RECORD OF APPEAL

B.A.R. Case # BAR 2004 - 0153

Address of Project: 407 South Washington St.

ISSUE: Appeal of a decision of the Board of Architectural Review, Old and Historic Alexandria District denying a Certificate of Appropriateness for alterations

Figure 1 400 block of South Washington Street

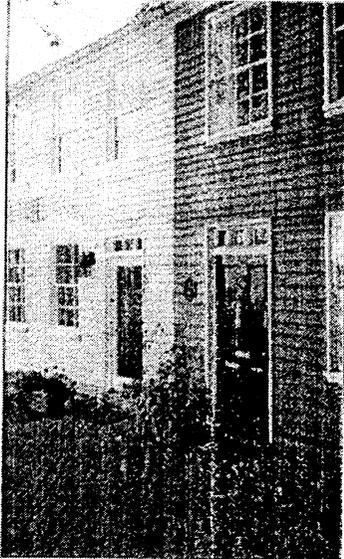
Figure 1 below shows the existing door and recessed transom. The Figure 2 drawing for the new door is misleading. Superficially it appears as if the new door will replicate the existing pattern of the transom. However, the new door and faux transom will all be on the same plane. Thus, there will be a significant difference between the existing door and recessed transom with the new door with the faux transom.

The drawings are somewhat misleading because they show no shadow lines indicating the change of plan of the existing transom. Therefore, the door appears to be almost identical in both drawings when, in fact, there is a significant difference.

Figure 2 Proposed replacement door with faux transom

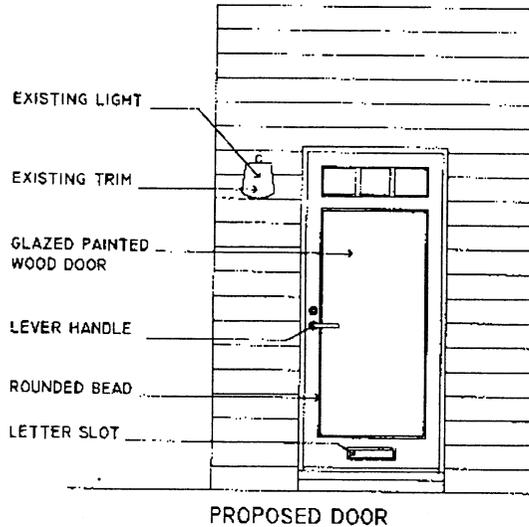
Staff is strongly opposed to changing out the door and transom to a single plane door that has lights at the top. First, it will substantially change the appearance of the building. Second, it will destroy a character defining feature of the house and, third, it will disrupt the unity of the row. Fourth, the change will destroy the historic architectural integrity of the building and the row which have survived remarkably unchanged on the exterior for nearly a century and a half. For these reasons, Staff recommends denial of the application.
